FirstEnergy submits the following questions and comments to MISO regarding their Cross-Border Network Service Proposal. This was presented at the 11/30/12 MISO-PJM JCM Meeting in Chicago (20121130-item-02-cross-border-network-service-proposal.pdf).

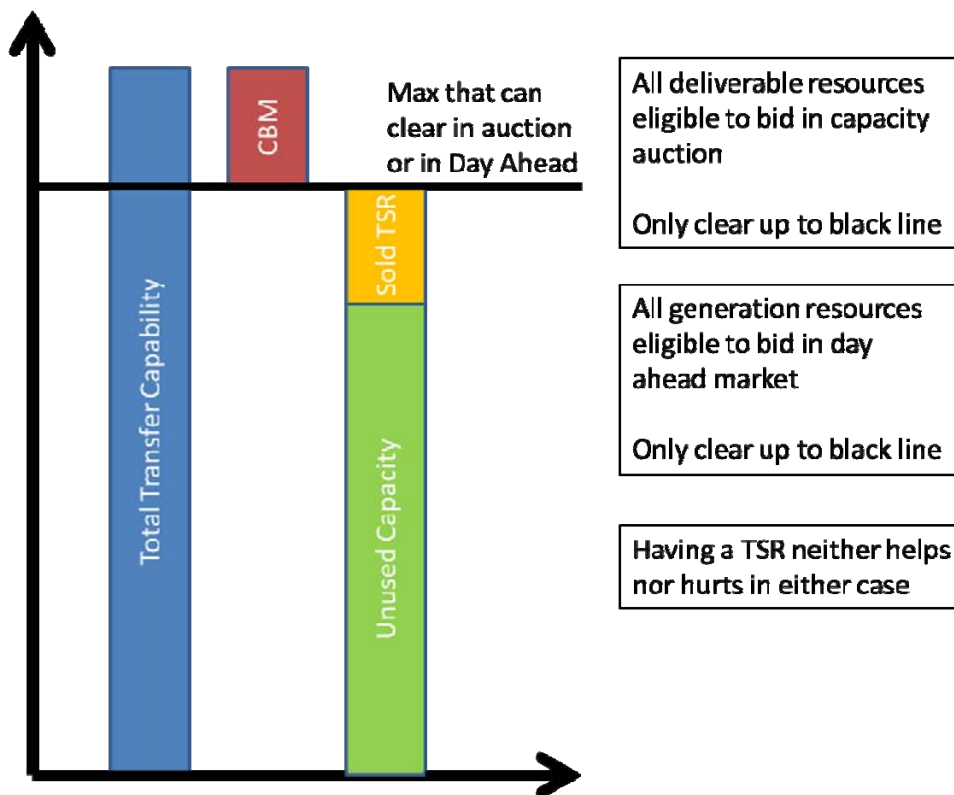
2) The Whitepaper implies that existing capacity transactions are compromised by implementation of Capacity Market Awarded Firm Transmission Service (CMAFTS) ("Network Service across the seam" in that paper's vernacular). What about this process compromises the rights of existing transactions, making it necessary to assign Capacity Transfer Rights (CTRs) to make them whole? Would this proposal terminate and supersede existing rights? How would the cost of these CTRs be recovered?

MISO Answer: It really doesn't. In the absence of CMAFTS usage, customers with existing Firm service are not guaranteed to deliver in the operating day. Any transmission constraint that binds can affect the ability of a transmission customer to schedule on their firm service. Adding the CMAFTS into the equation merely raises the number of bidders required to offer their generation into the market. It doesn't change the ability of an existing customer to bid into either the capacity market or in the energy market. It doesn't change the physical capability of the system in either the day-ahead horizon or the 3-year forward horizon. (See Diagram below)
